E/ECE/324
E/ECE/TRANS/505 } Rev.1/Add.62/Amend.1

Addendum 62 : Regulation No. 63

Amendment 1

UNIFORM PROVISIONS CONCERNING THE APPROVAL OF TWO-WHEELED MOPEDS WITH REGARD TO NOISE

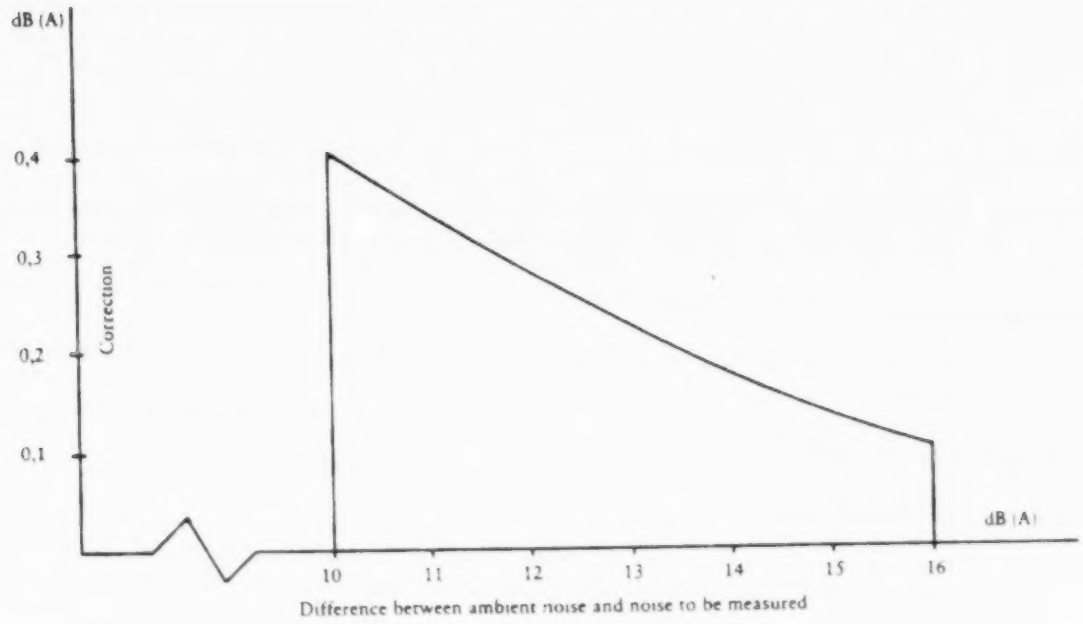
Paragraph 2.1.3., amend to read:

If the difference between ambient and measured noise-levels is between 10 and 16 dB(A), the appropriate figure shall be subtracted from the value recorded by the sound-level metre, in accordance with the following graph:

Figure 3

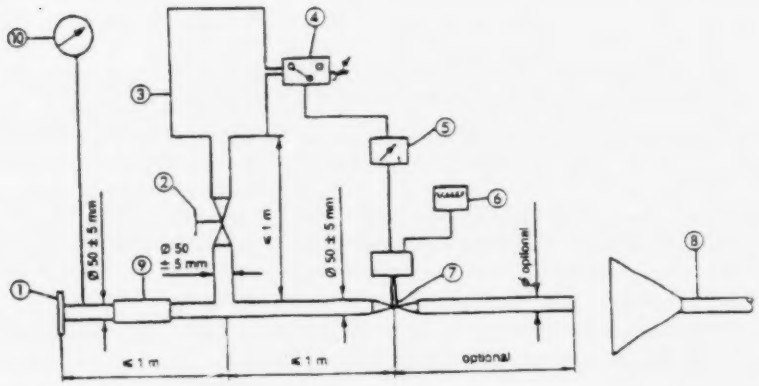
Insert a new figure 3 as follows:

"TEST APPARATUS FOR CONDITIONING BY PULSATION

1. Inlet flange or sleeve for connection to the rear of the test exhaust system.

2. Hand-operated regulating valve.

3. Compensating reservoir with a maximum capacity of 40 l and a filling time of not less than one second.

4. Pressure switch with an operating range of 0.05 to 2.5 bar.

5. Time delay switch.

6. Pulse counter.

7. Quick-acting valve, such as exhaust brake valve 60 mm in diameter, operated by a pneumatic cylinder with an output of 120 N at 4 bar. The response time, both when opening and closing, must not exceed 0.5 seconds.

8. Exhaust gas evacuation.

9. Flexible pipe.

10. Pressure gauge."

Figure 1:

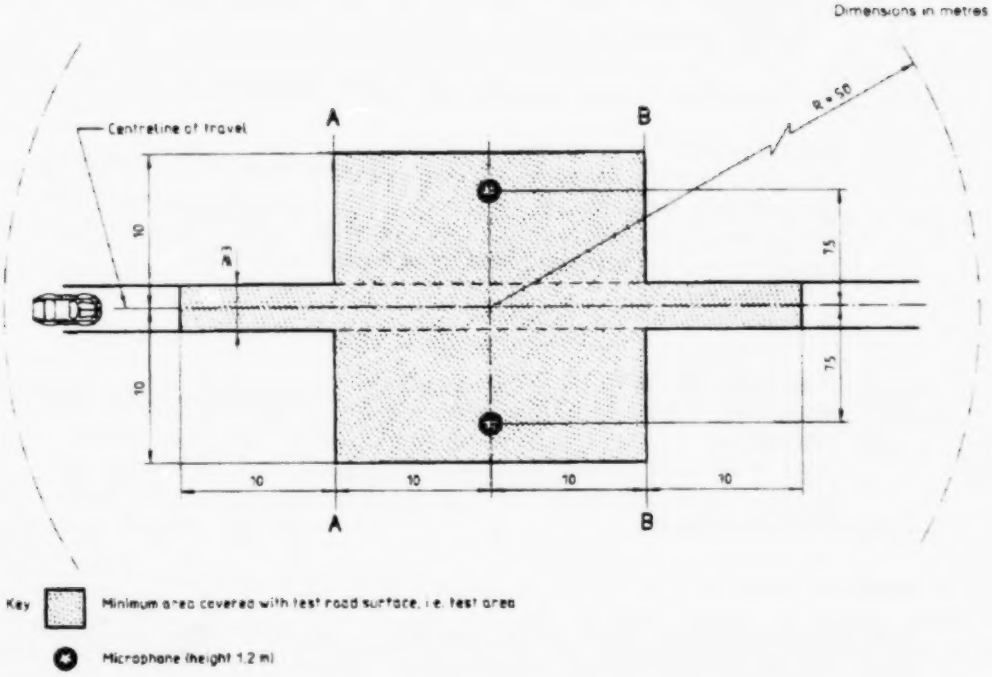
Insert the following new Annex 5:

3.1. Area

When designing the test track layout it is important to ensure that, as a minimum requirement, the area traversed by the vehicles running through the test strip is covered with the specified test material with suitable margins for safe and practical driving. This will require that the width of the track is at least 3 m and the length of the track extends beyond lines AA and BB by at least 10 m at either end. Figure 1 shows a plan of a suitable test site and indicates the minimum area which shall be machine laid and machine compacted with the specified test surface material. According to annex 3, paragraph 3.1.1.1., measurements have to be made on each side of the vehicle. This can be made either by measuring with two microphone locations (one on each side of the track) and driving in one direction, or measuring with a microphone only on one side of the track but driving the vehicle in two directions. If the former method is used, then there are no surface requirements on that side of the track where there is no microphone.

NOTE — There shall be no large acoustically reflective objects within this radius.

Minimum requirements for test surface area.
The shaded part is called "Test Area".

Figure 2: Grading curve of the aggregate in the asphaltic mix with tolerances.

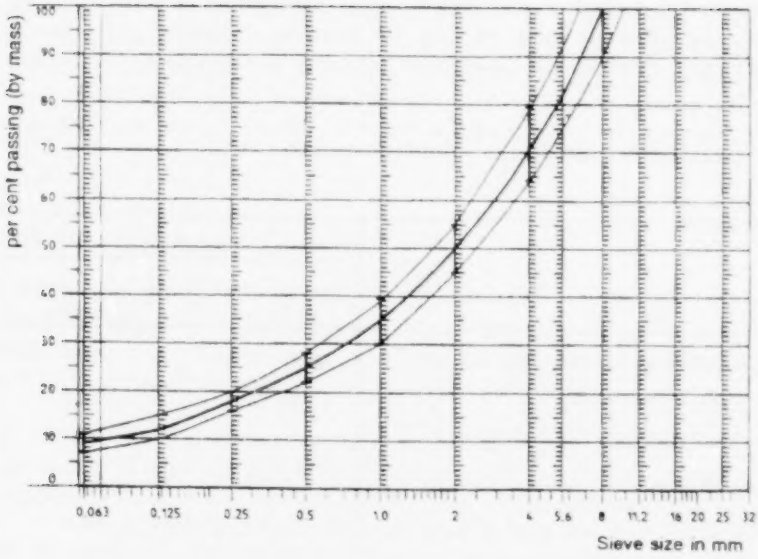
3.2.2. Design guidelines

As a guide to the surface constructor, an aggregate grading curve which will give desired characteristics is shown in Figure 2. In addition, Table 1 gives some guidelines in order to obtain the desired texture and durability. The grading curve fits the following formula:

$$P\ (\%\ \text{passing}) = 100 \cdot (d/d_{max})^{1/2}$$

where: d = square mesh sieve size, in mm
d_{max} = 8 mm for the mean curve
d_{max} = 10 mm for the lower tolerance curve
d_{max} = 6.3 mm for the upper tolerance curve
